Video Products Technical Bulletin 30-2008-089

SUBJECT: **PICTURE SHAKES HORIZONTALLY WHEN UNDER-SCANNED**

MODEL: **PVM-14L5**
PVM-20L5
PVM-D14L5A
PVM-D20L5A

Figure 1

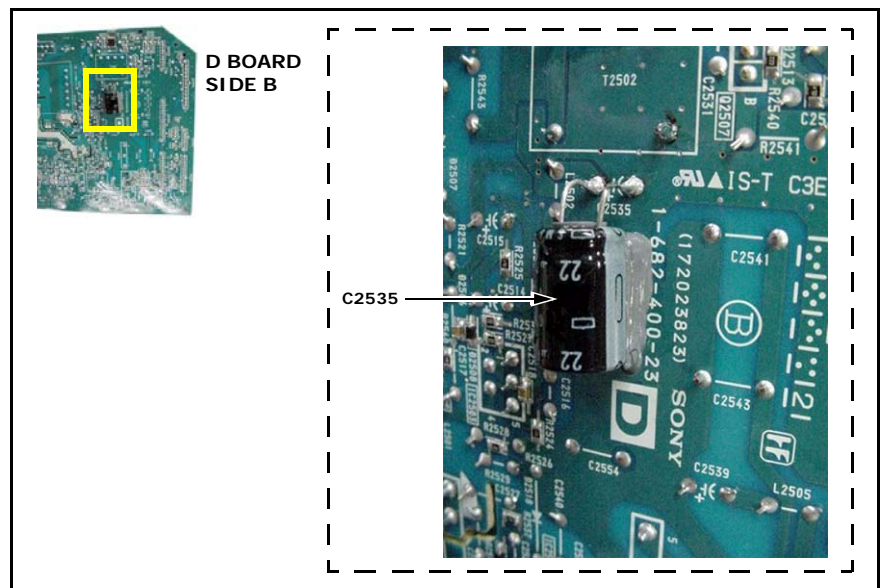
The picture may shake horizontally when under-scanned.

1. Replace C2535 with a new 105° C-type capacitor. (See Figure 1.)
2. Affix the capacitor to the board with RTV.
